ZONING CHANGE REVIEW SHEET

CASE: C814-2017-0001 – 425 W. Riverside PUD

ADDRESS: 425 W. Riverside Drive

ZONING FROM: CS-1-V-NP **TO:** PUD-NP

EXHIBIT F - LAND USE PLAN-OPEN SPACE

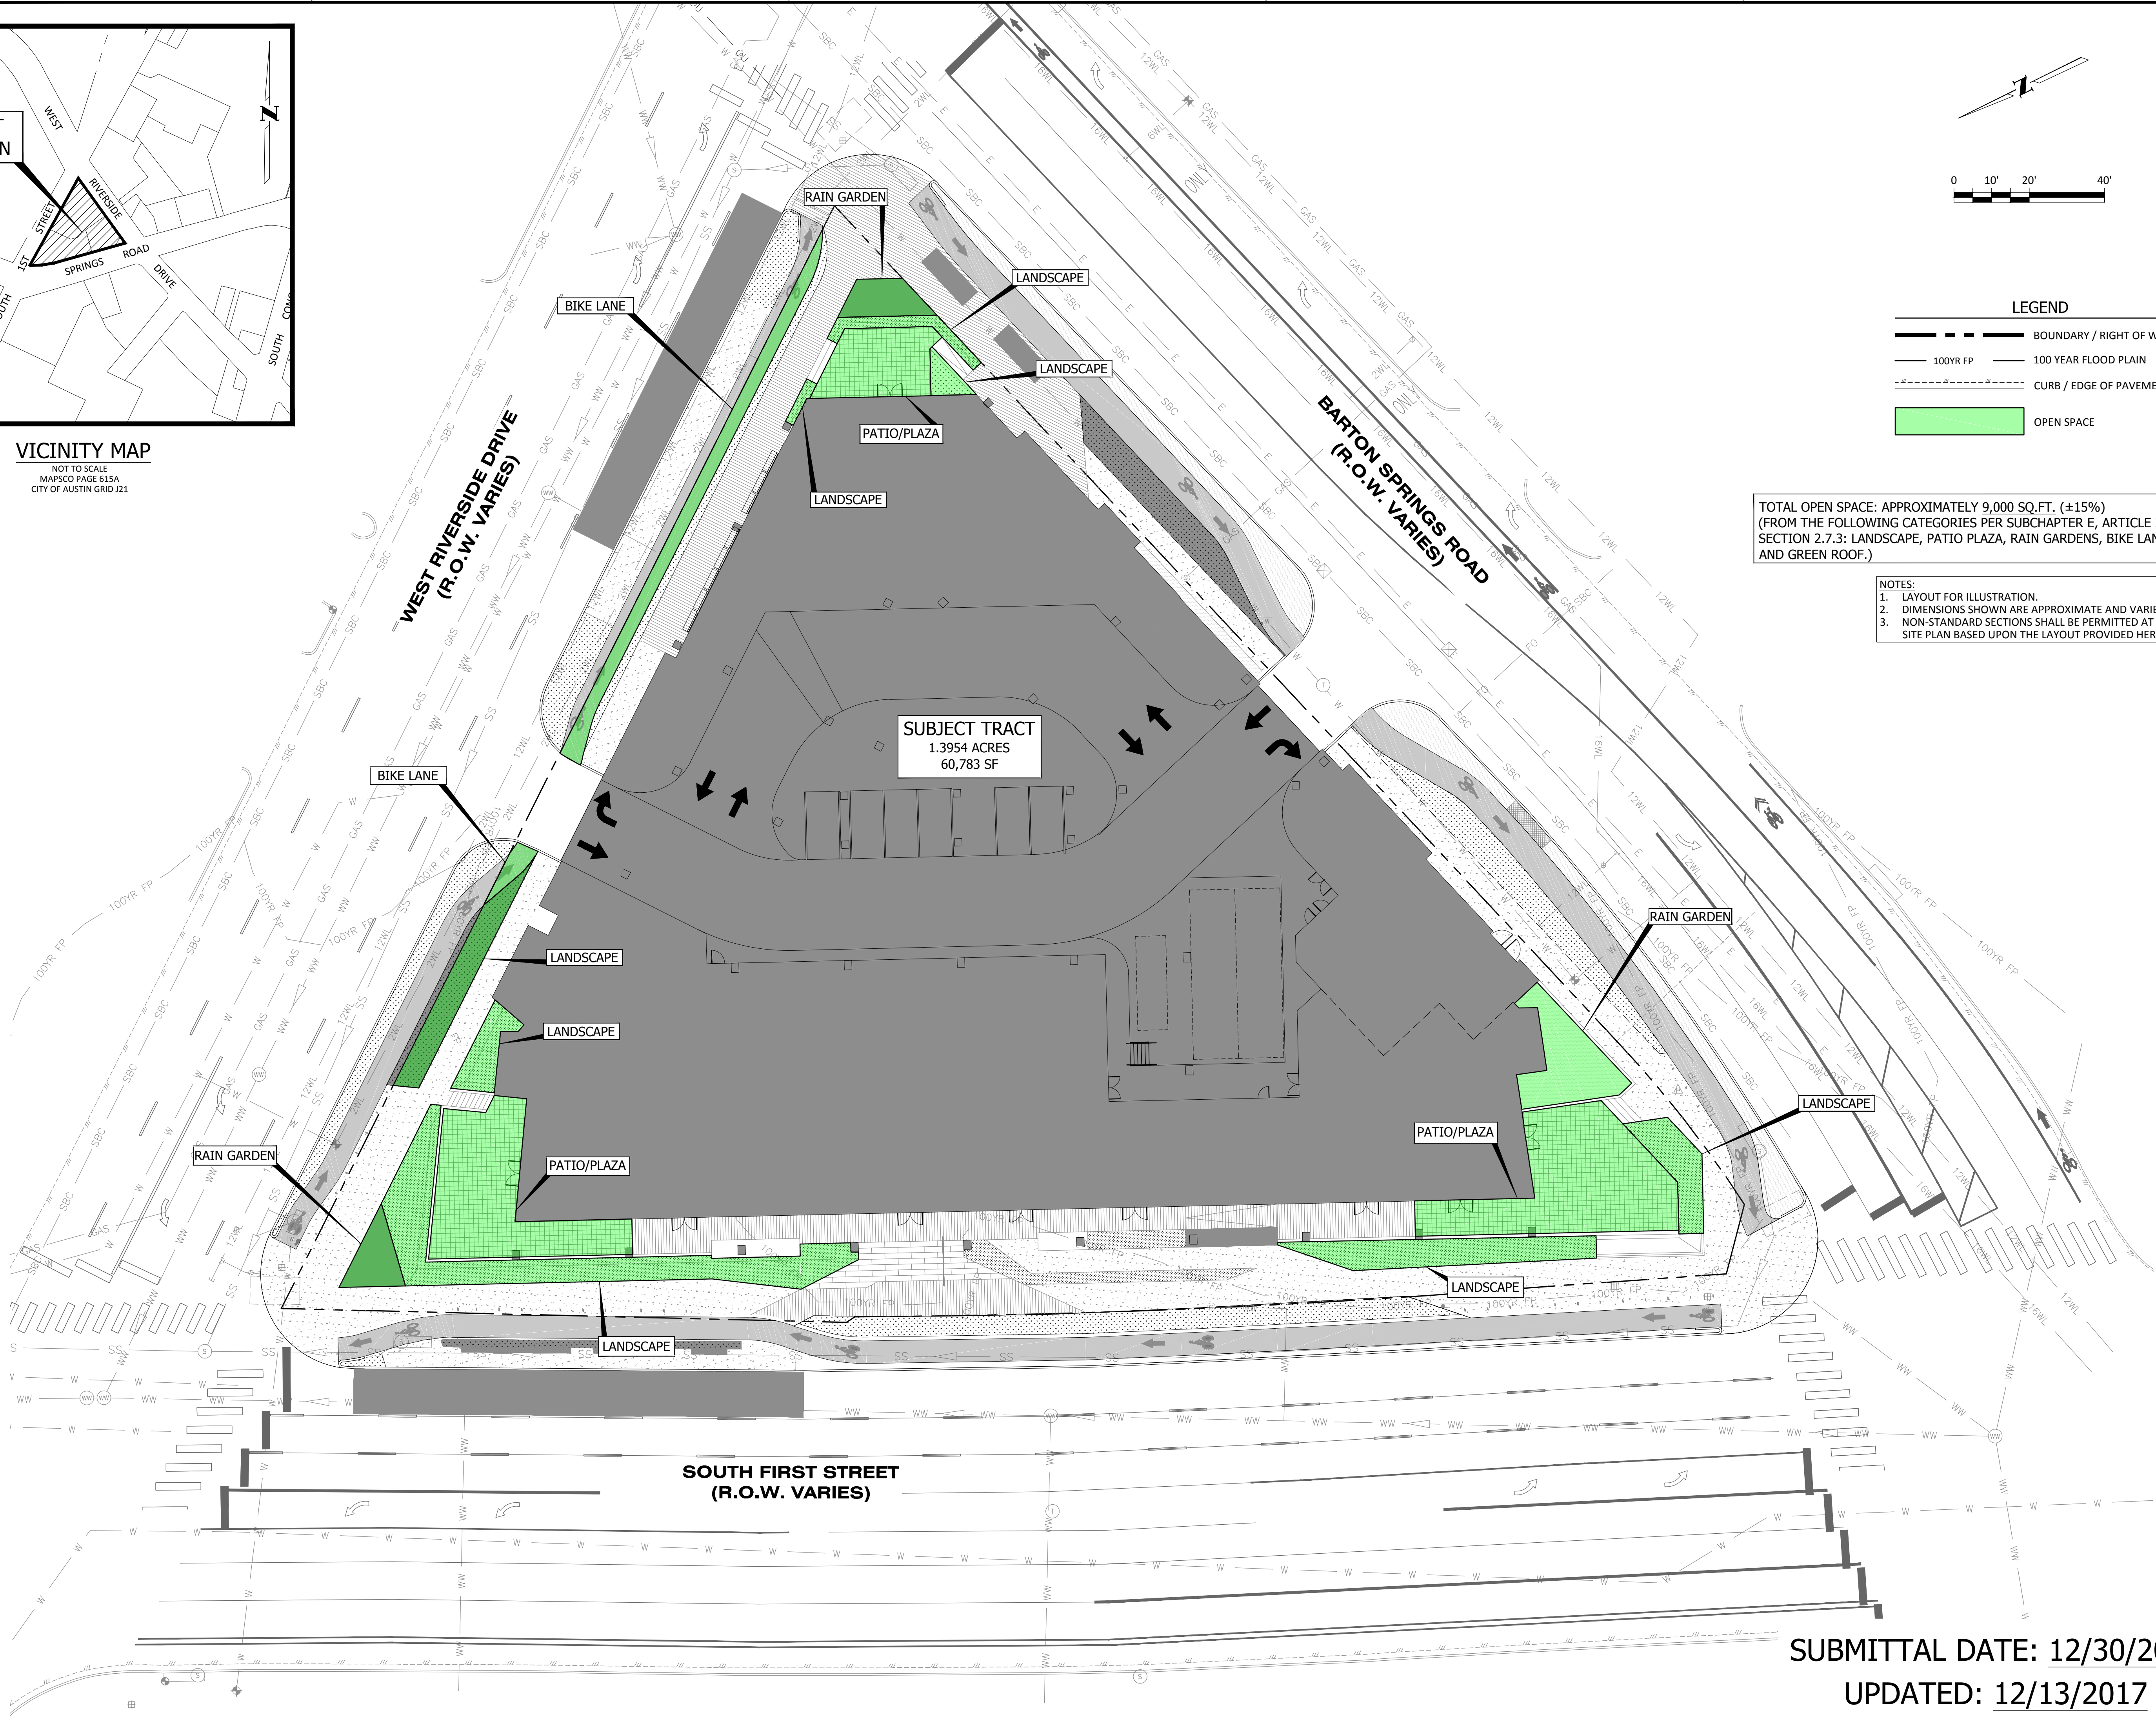
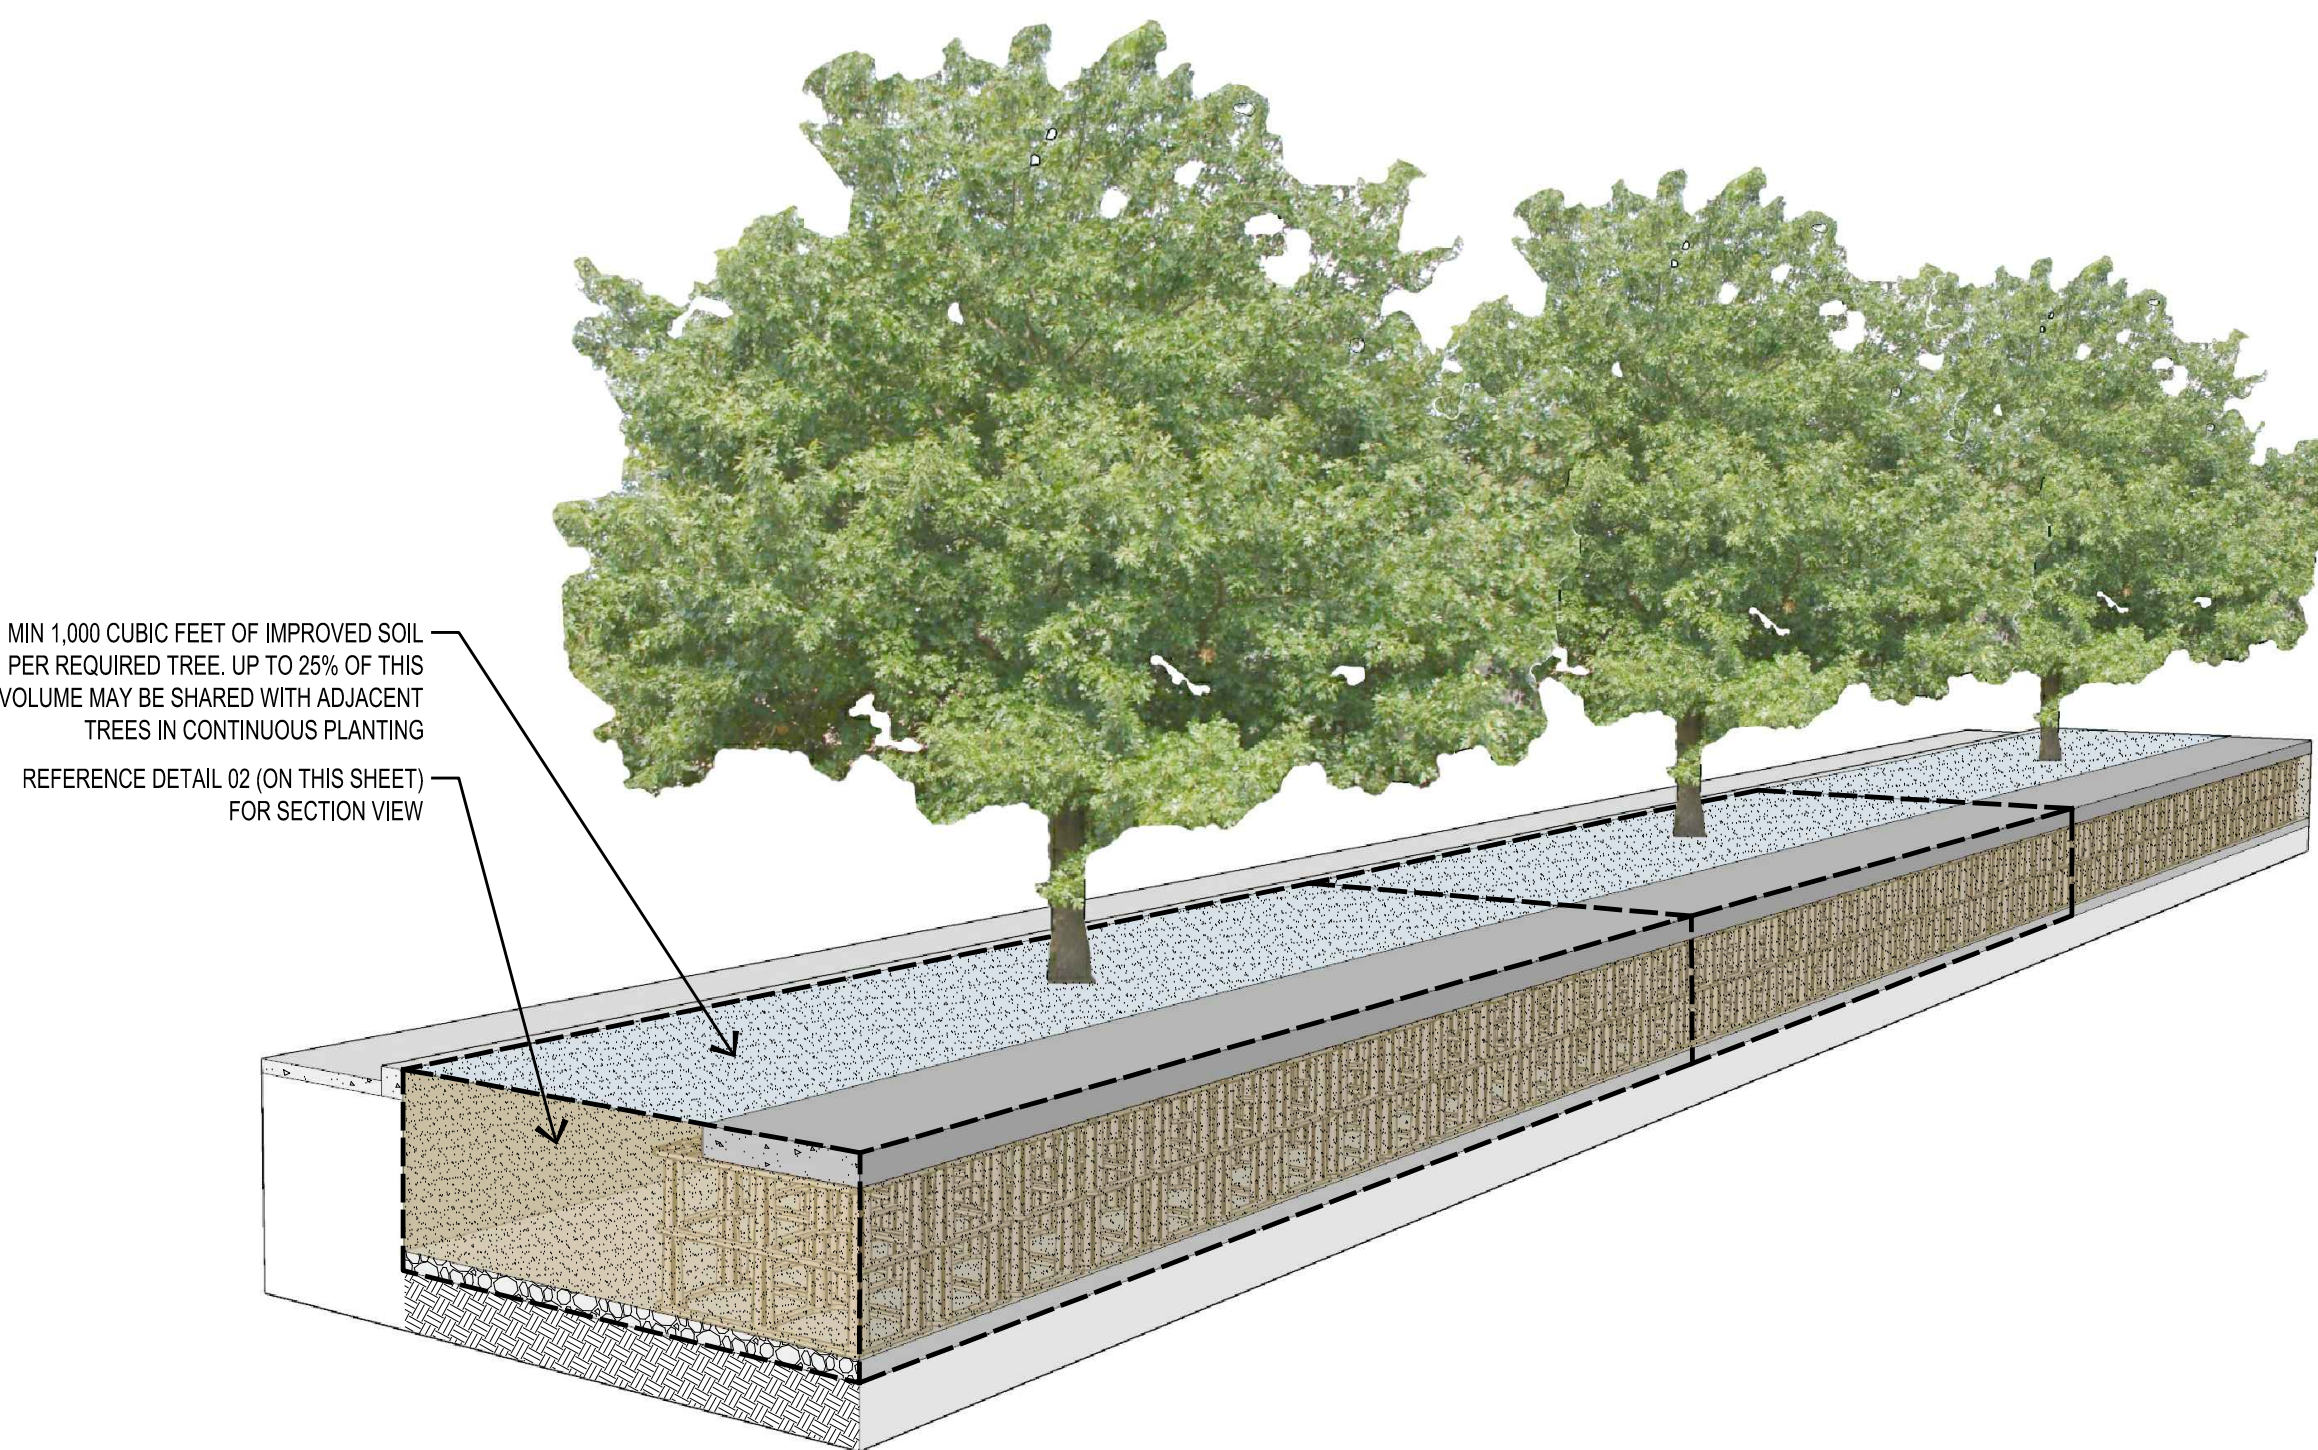
U3: The proposed Open Spaces A, B, C, and D (green roof) are acceptable, as is the minimum commitment of 15% of the site. However, please prepare an open space exhibit that can be included with the PUD ordinance. (Something like the submitted exhibit can be used, but it currently says “for informational purposes only – Update 2”). This comment can be cleared informally.
